Access Compliance Report

Public Rights-of-Way

Intersection ID: 5646	Main Street: MCCULLOUGH_DR	Cross Street: COLLINS-AIKMAN_DR	Location: NW
ADA ID: 1DDF492DDBF6	Ramp Type: BlendTrans1	Initial Pass/Fail: Fail	Overall Compliance: No
		Severity Score: 10

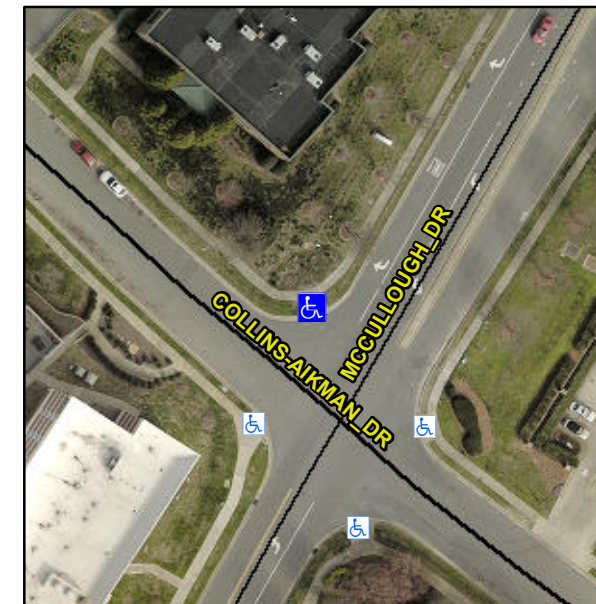
Not Found, R304.5.1, R304.5.3

Compliance	Description	Data	Compliance	Description	Data
N/A	Ramp Length (in)	98.0	Yes	BlendTrans Slope (%)	4.6
No	Ramp Width (in)	47.0	No	BlendTrans XSlope (%)	3.4
N/A	Flare Type LT	N/A	N/A	Flare Type RT	N/A
N/A	Flare Slope LT (%)	N/A	N/A	Flare Slope RT (%)	N/A
N/A	Flare Traversable LT?	N/A	N/A	Flare Traversable RT?	N/A
N/A	Landing Length (in)	N/A	N/A	DWS Provided?	N/A
N/A	Landing Width (in)	N/A	N/A	DWS Contrast?	N/A
N/A	Landing Slope (%)	N/A	N/A	DWS Length (in)	N/A
N/A	Landing X Slope (%)	N/A	N/A	DWS Full Width?	N/A
N/A	Landing Curb? (Y/N)	N/A	N/A	DWS Offset (in)	N/A
N/A	Shared Landing?	N/A			
N/A	Gutter Ponding?	N/A	N/A	Gutter Slope (%)	N/A
N/A	Gutter Lip Ht (in)	N/A	N/A	Gutter X Slope (%)	N/A
N/A	Painted X Walk1?	No	N/A	Painted X Walk2?	No
	X Walk 1 Direction	To SW		X Walk 2 Direction	To SE
	X Walk 1 Width (in)	N/A		X Walk 2 Width (in)	N/A
	X Walk 1 Slope (%)	7.1		X Walk 2 Slope (%)	4.3
	X Walk 1 X Slope (%)	0.3		X Walk 2 X Slope (%)	8.5

Remove & Replace Curb Ramp With Two New Directional Ramps or Equivalent.
